LAKE HAVASU CITY, ARIZONA

ADDENDUM NO. 4

Lake Havasu City Booster Station 4 Improvements  
PROJECT NO. 108029

December 11, 2023

31. *Canopy Photo at the site show below for information as requested.*

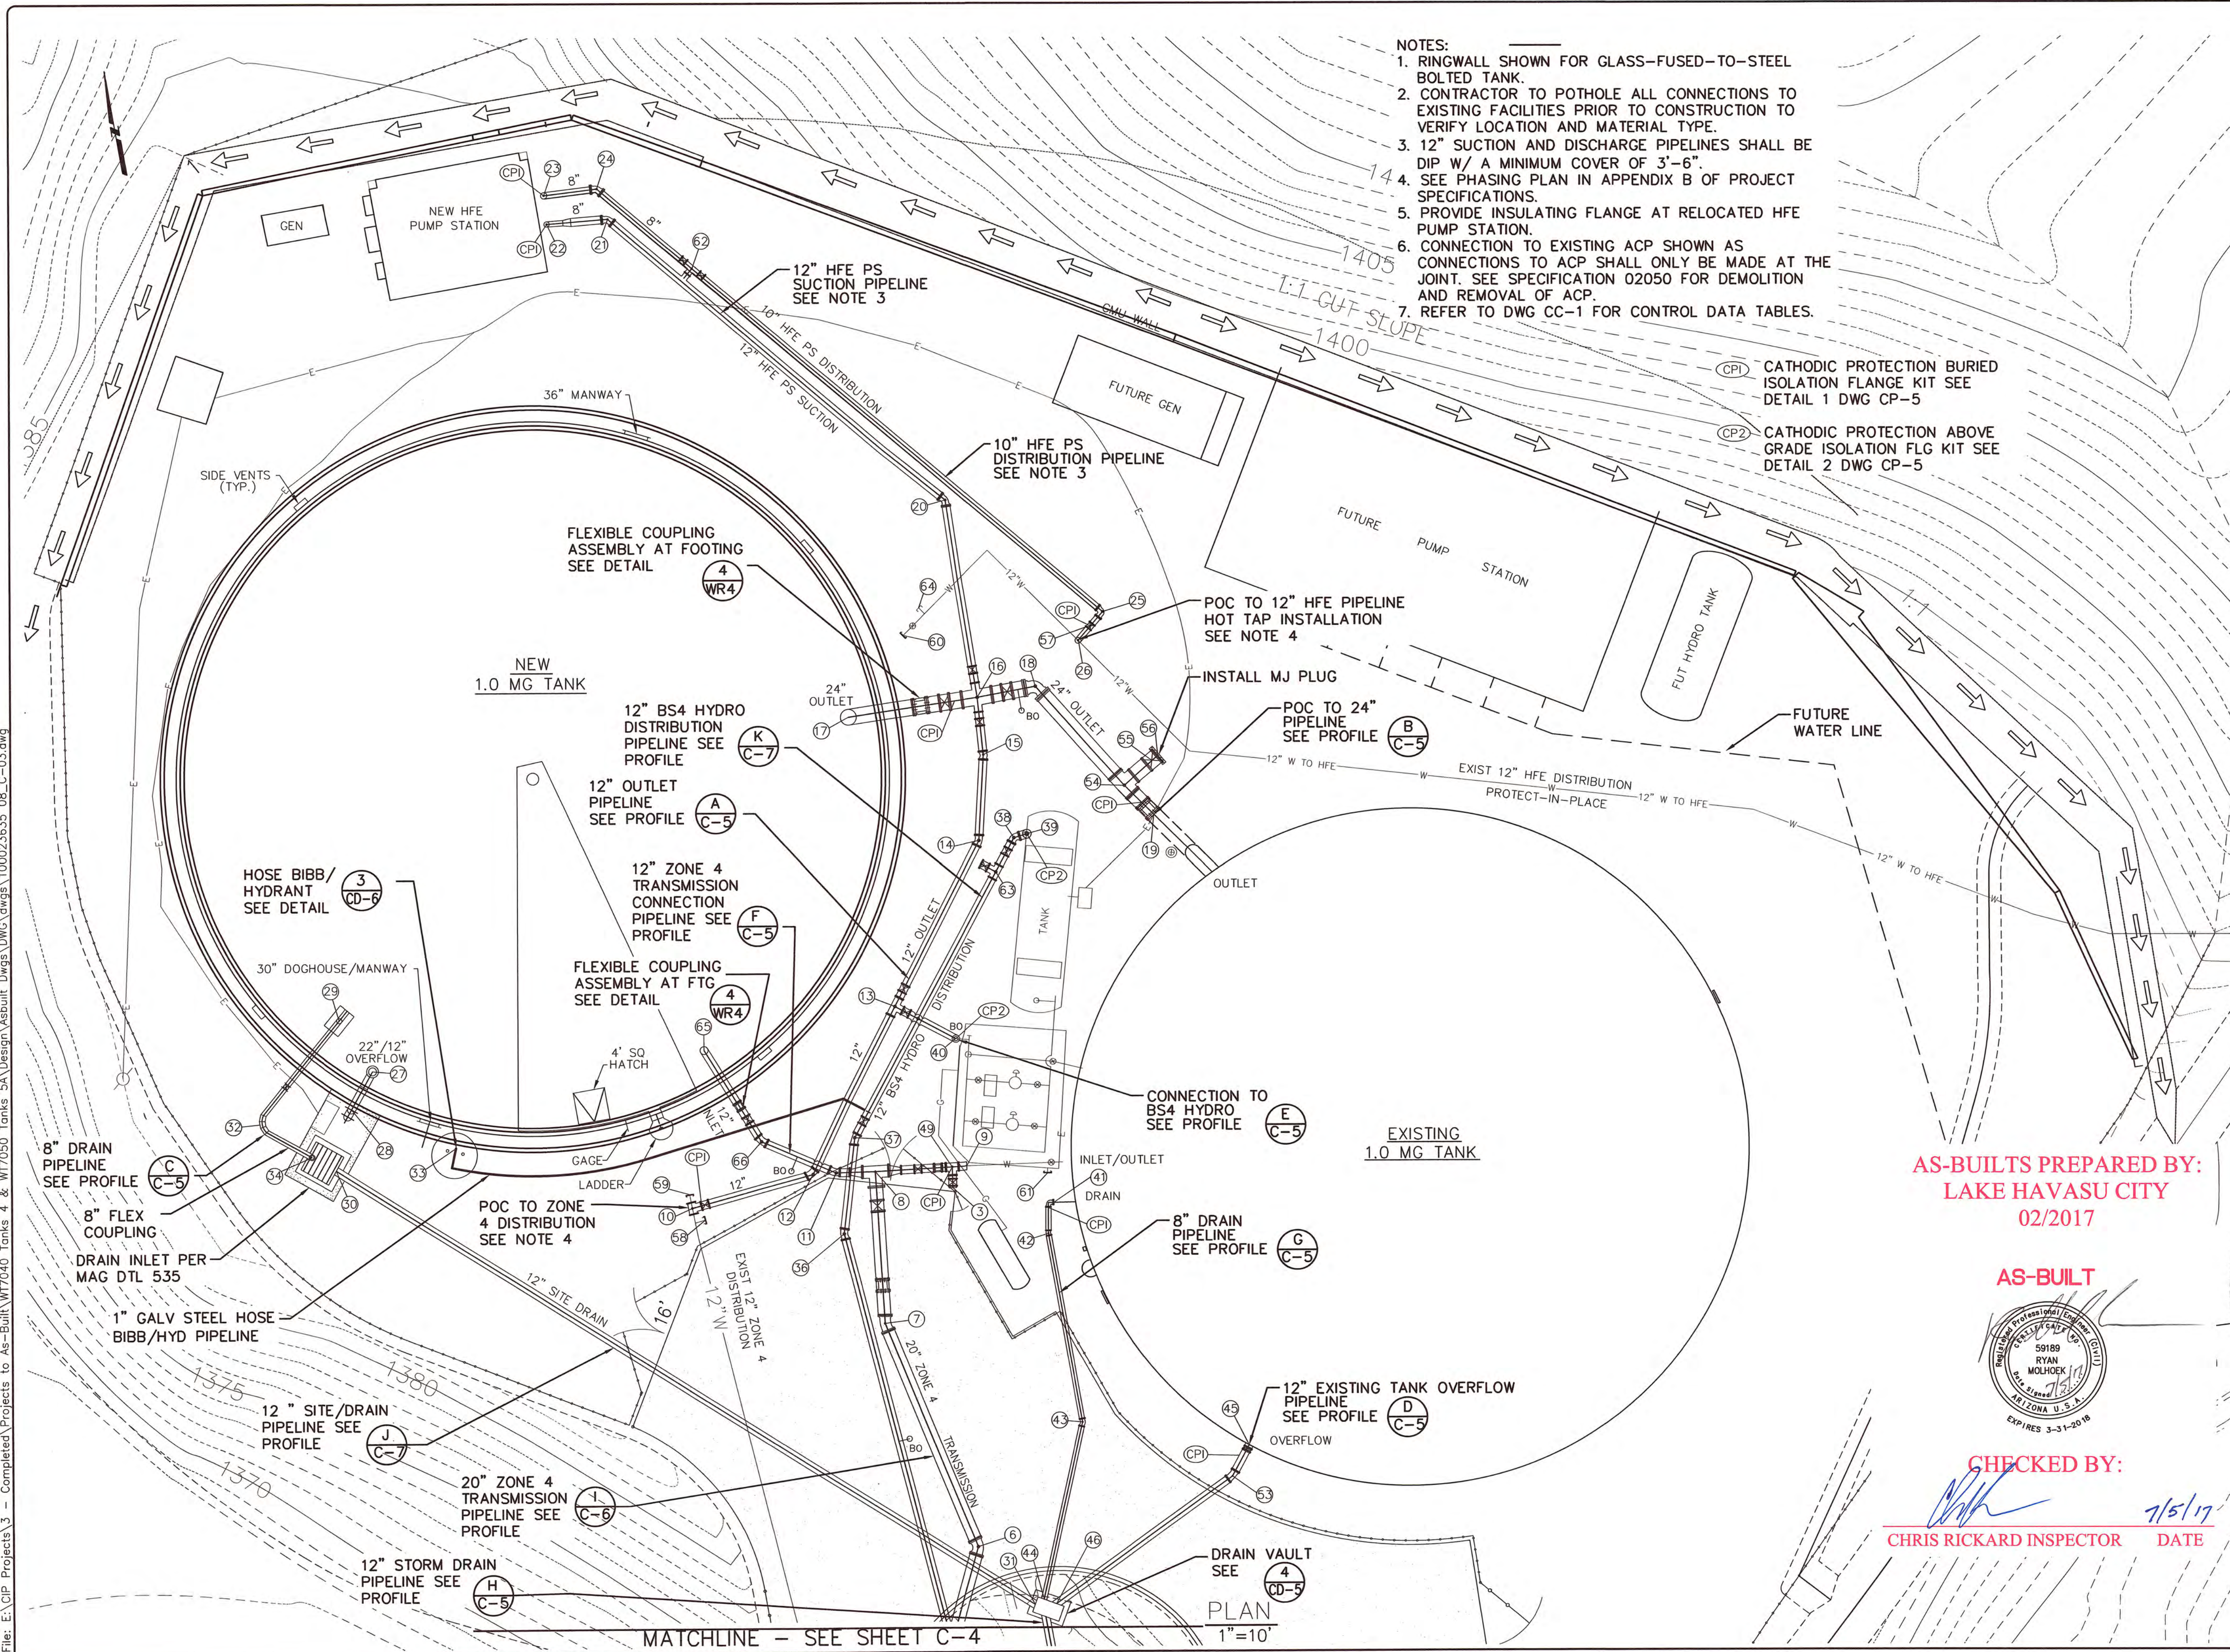
30. Will a site walk be made available? If not, can photos of the existing shade canopy be provided?

*Answer: Non-mandatory pre bid was held on November 30, 2023 @ 1:30 pm. Site photos can be provided.*
